Responses to USEPA 6/23/12 TSCA-Related Questions

PROJECT	NEW BEDFORD MARINE COMMERCE TERMINAL	OWNER	MASSACHUSETTS CLEAN ENERGY CENTER 55 SUMMER STREET, 9TH FLOOR BOSTON, MASSACHUSETTS

V-5.3

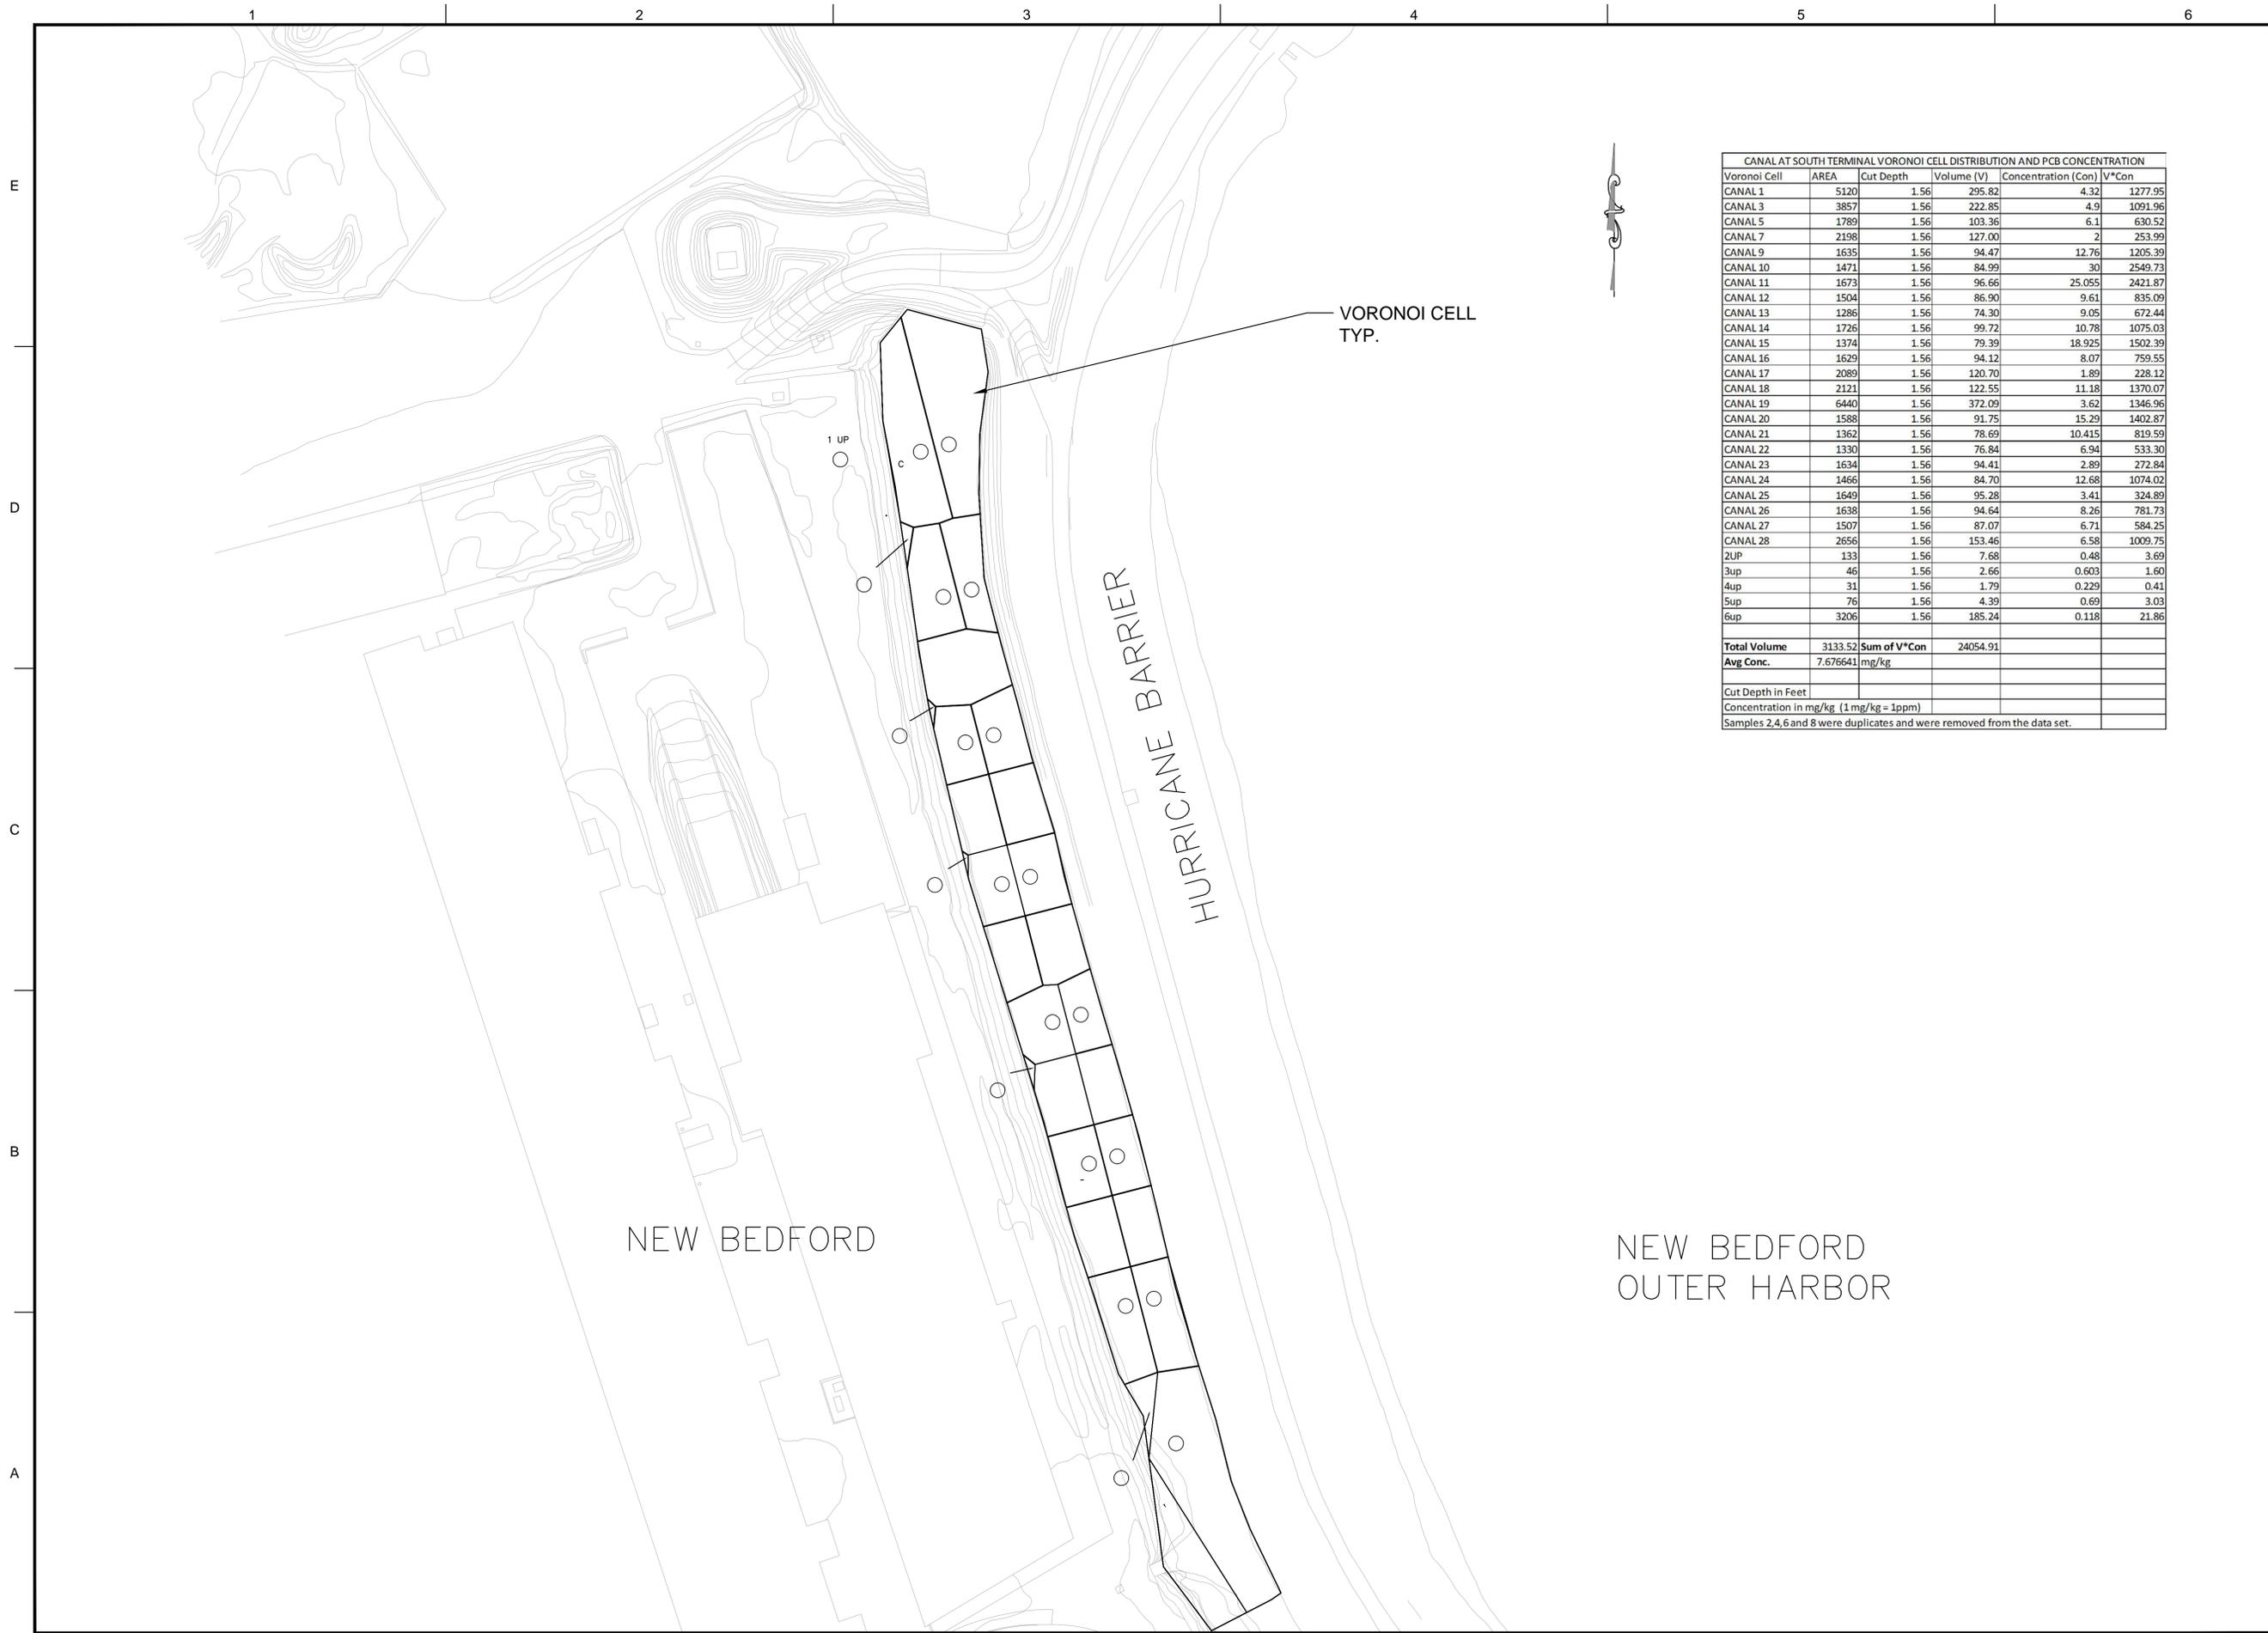
- Question:** *What is the current proposed management of the drainage swale sediments? Is it still proposed to manage these sediments in CAD-2? If so, how does the concentration of all cocs in the drainage swale sediments compare to the cocs concentrations in the harbor sediments that will be dredged during the ST project?*

Response: The Commonwealth currently anticipates that the drainage swale sediments will be placed into CAD Cell #2. The Constituents of Concern in the Stormwater Drainage Swale Mitigation Area are generally higher in concentration than other sediments to be dredged associated with the New Bedford Marine Commerce Terminal; however, please note that the New Bedford Marine Commerce Terminal sediments are to be placed within CAD Cell #3. The concentrations of Constituents of Concern in the Stormwater Drainage Swale Mitigation Area are generally the same or lower than the concentrations of Constituents of Concern for other sediments that have previously been dredged during the Phase III Navigational Dredge project under the State Enhanced Remedy process and placed within CAD Cell #2. A drawing showing the concentration of PCBs within the Stormwater Drainage Swale Mitigation Area as well as the average concentration of PCBs (7.67 mg/kg) for sediments within the Stormwater Drainage Swale Mitigation Area as well as a summary of the material that has historically been placed within CAD Cell #2 is included as **Attachment A**.

Analytical data for samples collected within the Stormwater Drainage Swale Mitigation Area (including samples collected below Mean High Water, labeled "CANAL" and samples collected above Mean High Water, labeled "UP") is contained within Appendix 73 of the Commonwealth's January 18, 2012 submittal to EPA. Please note that a report from 2007 was also included within Appendix 73 of the Commonwealth's January 18, 2012. Conversations with EPA personnel have indicated that there is some confusion regarding the object and content of this report, in particular the pictures associated with the report. The photos contained within this document are not indicative of the section of the Stormwater Drainage Swale under consideration for mitigation. The area under consideration is only the area between Cove and Gifford Street. Although one photograph (the bottom photograph on the second page) shows the southern portion of that area at a distance, none of the photographs are wholly representative of the area. The existing conditions of the area in question is best represented by the cross-section on Figure 16 of the Commonwealth's January 18, 2012 submittal to EPA.

NEW BEDFORD MARINE
 COMMERCE TERMINAL
 AREA FOR TSCA
 DETERMINATION

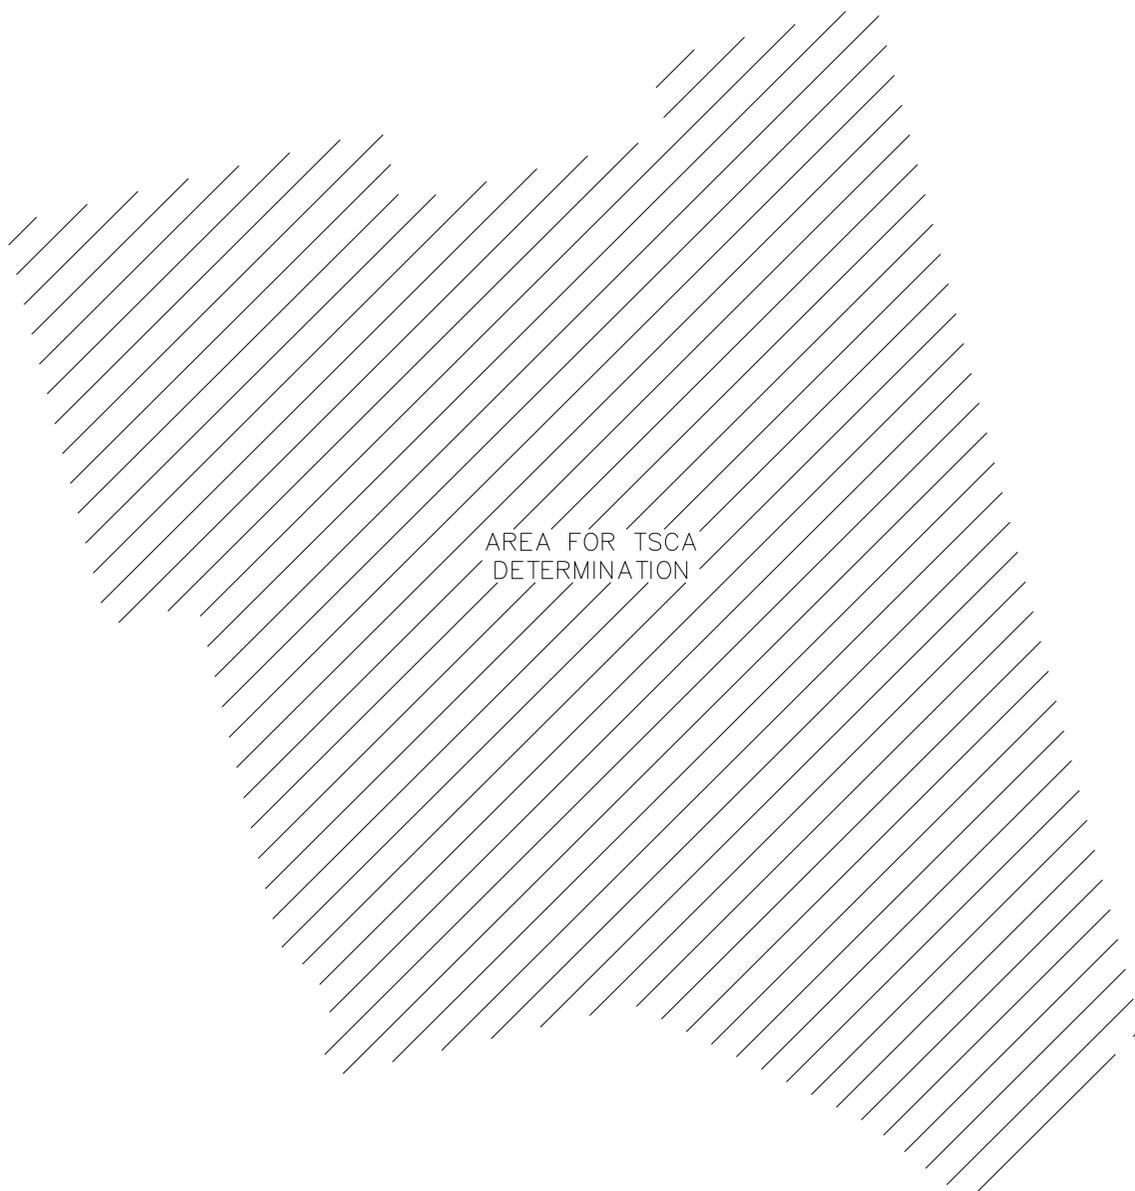
5. **Question:** *With respect to the upland area, the current plan proposes to removal and dispose of PCB-contaminated soils with > 25 ppm in 2 areas. There is also mention about the possibility of additional excavation of Pb-contaminated soils, which is still under review by the Commonwealth. Other than the Pb issue, is any additional sampling and/or site characterization proposed in the upland area for purposes of compliance with the MCP requirements?*

Response: The Commonwealth does not currently anticipate any additional sampling for delineation and/or site characterization for the purposes of compliance with MCP requirements.

The overall area of the site comprises multiple properties, at least two of which are MassDEP listed sites. The source of contamination at these locations is attributable to historic urban fill. Response actions at these sites have been undertaken under the supervision of one or more Licensed Site Professionals (LSP). At several of these locations a condition of No Significant Risk (NSR) has been achieved; therefore, it appears likely that the Commonwealth will similarly be able to achieve a condition of NSR at the New Bedford Marine Commerce Terminal.

The Commonwealth currently anticipates that, due to the absence of Pb-impacted groundwater onsite that the primary risk from Pb-impacted soil is from direct contact. Therefore, consistent with MCP standard practices, the Commonwealth plans to manage Pb-impacted soils onsite via: the re-grading of onsite soils; implementation of a 3-foot thick cap of granular material; and a deed restriction that will minimize direct contact with that material via an Activity and Use Limitation. This remedy will be assessed for its potential and future risk to current and future receptors via a Method 3 Risk Assessment, which will be completed prior to closure of the site. If any significant unanticipated risk to future receptors is identified during the Method 3 Risk Assessment, consistent with MCP standard practices, the proposed remedy will be re-evaluated.
